RE: Measuring Device Requirement for Sinker Creek

TO: Sinker Creek Water District 57D File
FROM: Cindy Hodges *CH*
RE: Diversion Works Inventory

Sinker Creek Water District 57D Diversion Works Inventory, June 30, 1995

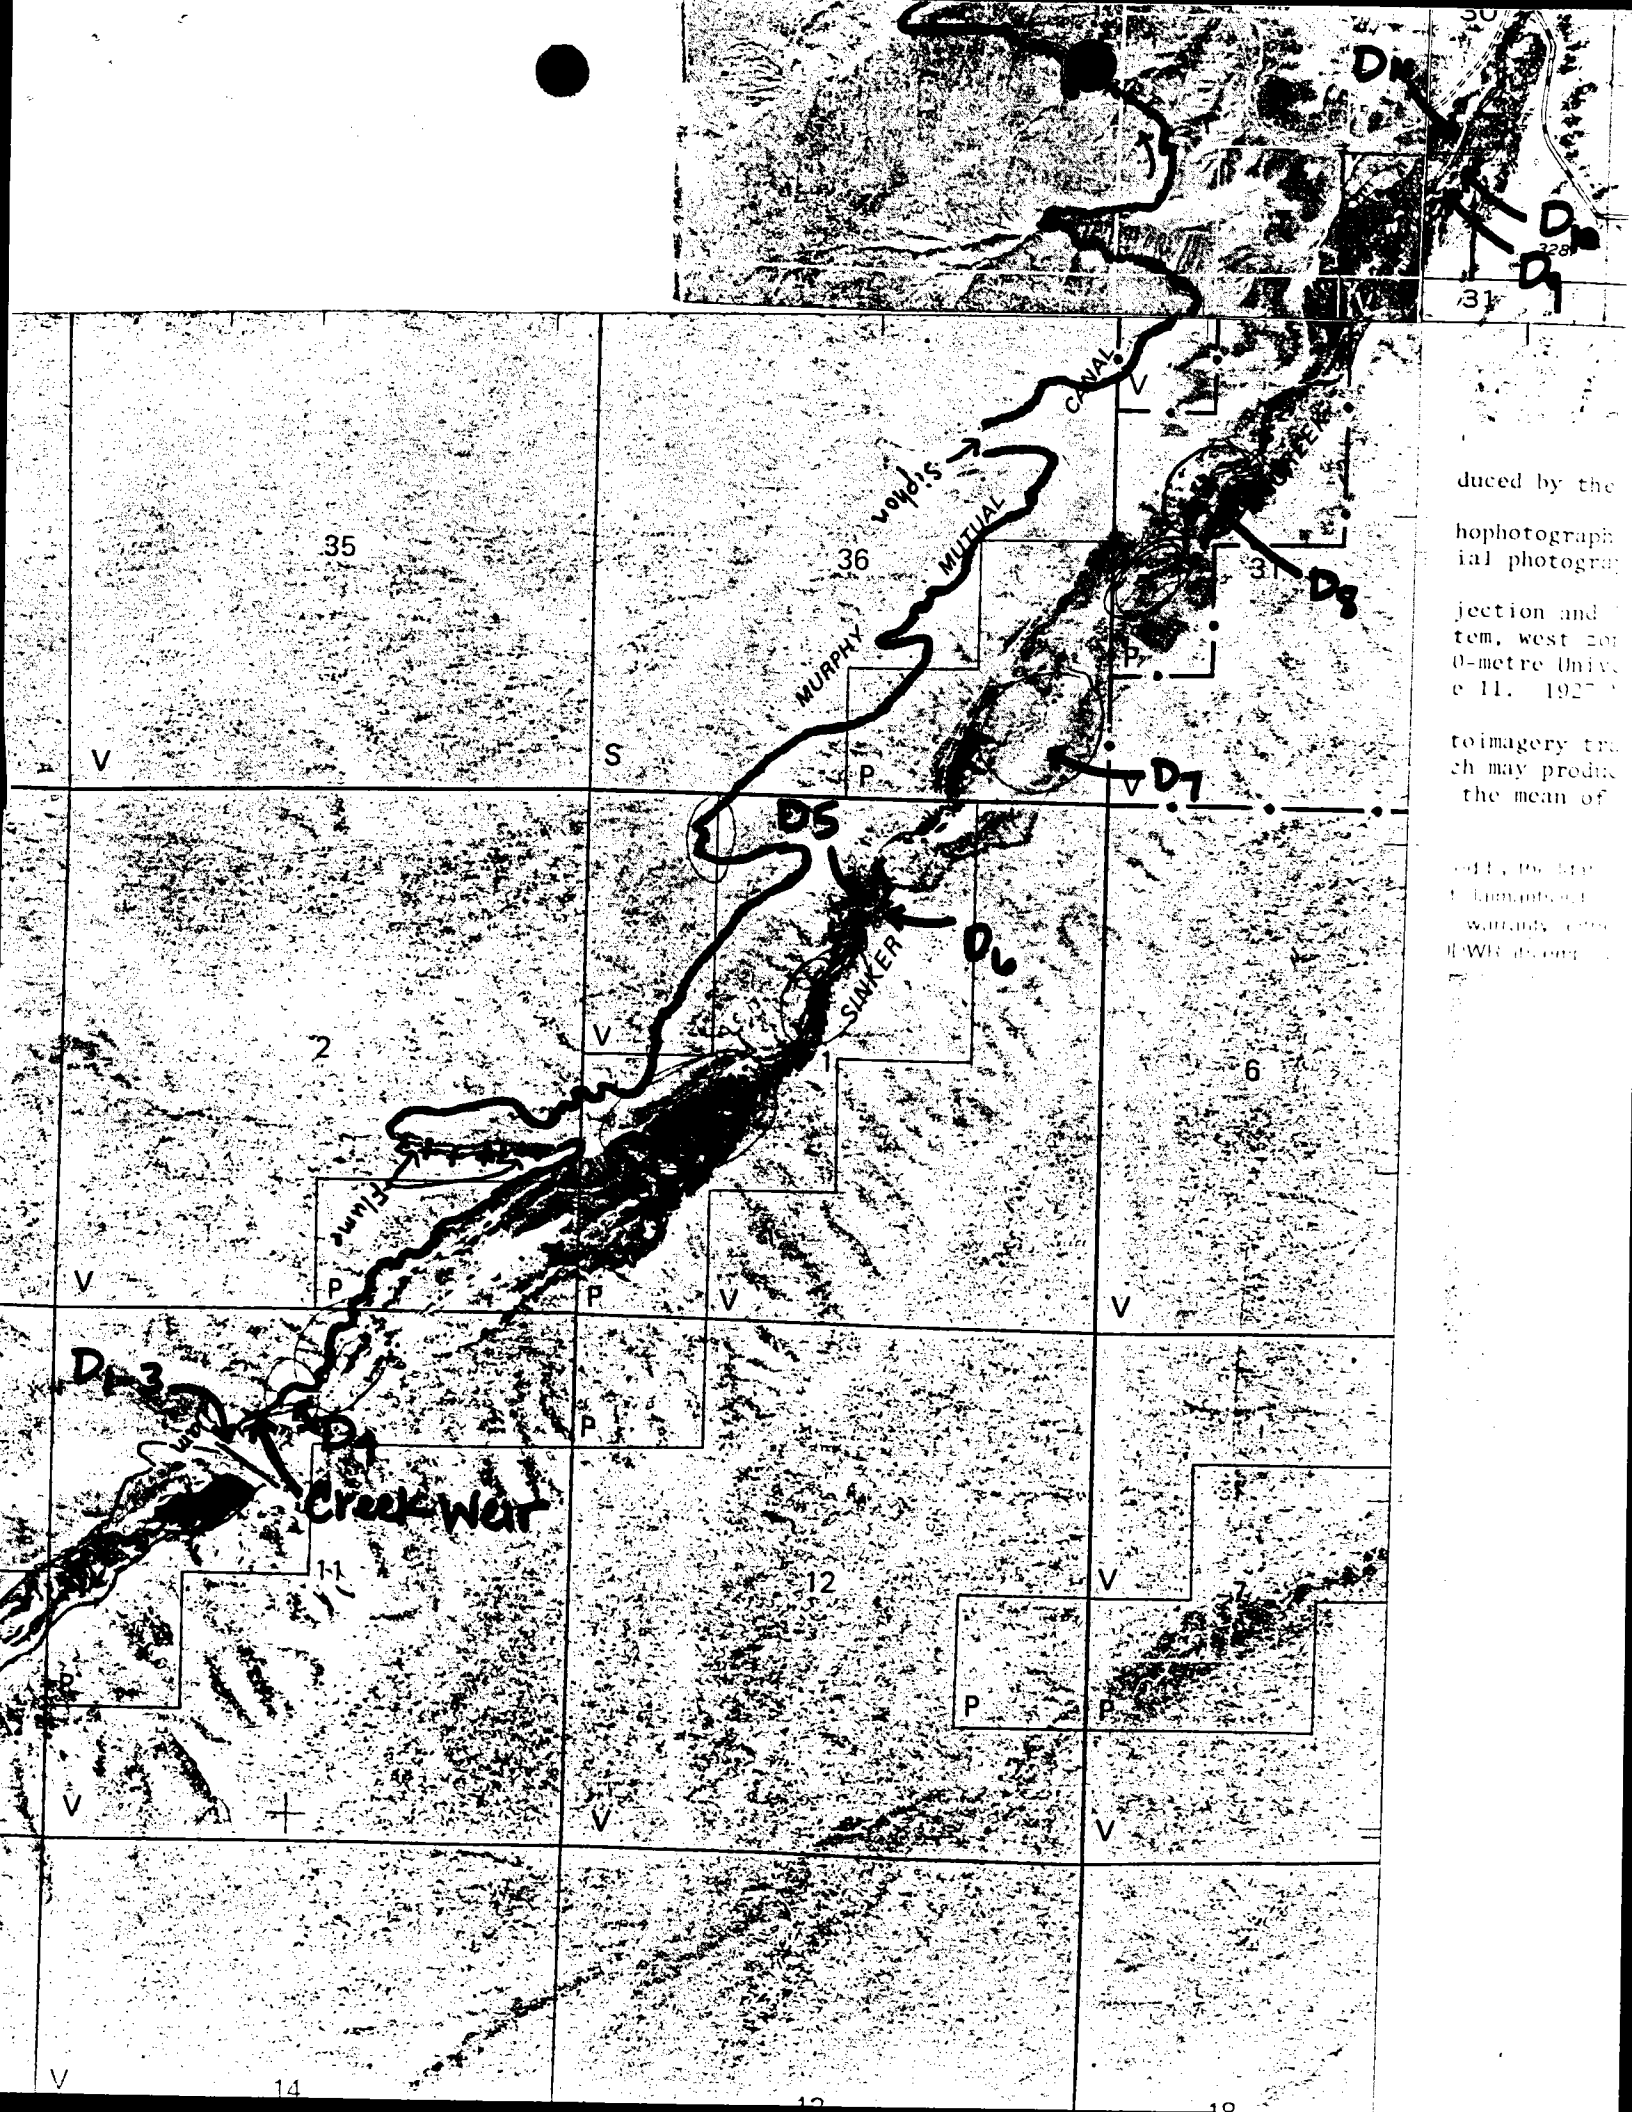
Diversion ID	Responsible Party	Control Structure	Measuring Device	Work Required, Comments
Reservoir Inlet	Hulet	N/A	10' Cipolletti weir	Weir washed out; needs to be reset.
D _{1,3} Murphy Mutual Canal	Hulet	Dam, headgate Lockable and secured	10' Cipolletti weir	Weir accurate only to 35 cfs then submerges. Control works satisfactory.
Creek Channel	Nettleton (gate) and Hulet (weir)	6' wood screw gate, lockable, not secured	5' Cipolletti weir	Both devices satisfactory.
D ₄	Nettleton	4' wood check box, not lockable	4' rectangular weir	Weir satisfactory. Check box must have locking mechanism.
D ₅ North side	Nettleton	None	3' Cipolletti weir (new)	Weir leaning downstream, inadequate weir pool. Needs material removed upstream from blade. Control works required.
D ₆ South side	Nettleton	None	3' Cipolletti weir (new)	Inadequate weir pool; needs material removed upstream from blade. Control works required.

D ₇	Nettleton	None	2' rectangular weir	Weir in poor condition: leaking, not level, submerged. Repair or replace. Control works required.
D ₈	Nettleton	None	2' rectangular weir	Weir satisfactory. Control works required.
D ₉ south side high ditch	Nettleton	None	2' rectangular weir	Weir fair; tilted downstream, needs pool slightly enlarged. Control works required.
D ₁₀ south side low ditch	Nettleton	None	2' rectangular weir	Control works required.
D ₁₁	Nettleton	None	None	Not in use. Works required for diversion.
D ₁₂	Tyson	None	1' Parshal flume	Not in use. Flume overgrown and possibly out of level. Flume maintenance and control works required for diversion.
D ₁₃	Nahas	5' W X 12' (?) concrete box, wood slide gate, not lockable	4' rectangular weir	Weir satisfactory for pipe capacity of ~4 cfs. Control works need locking mechanism at slide gate. Stockwater diversion screw gate may be locked.
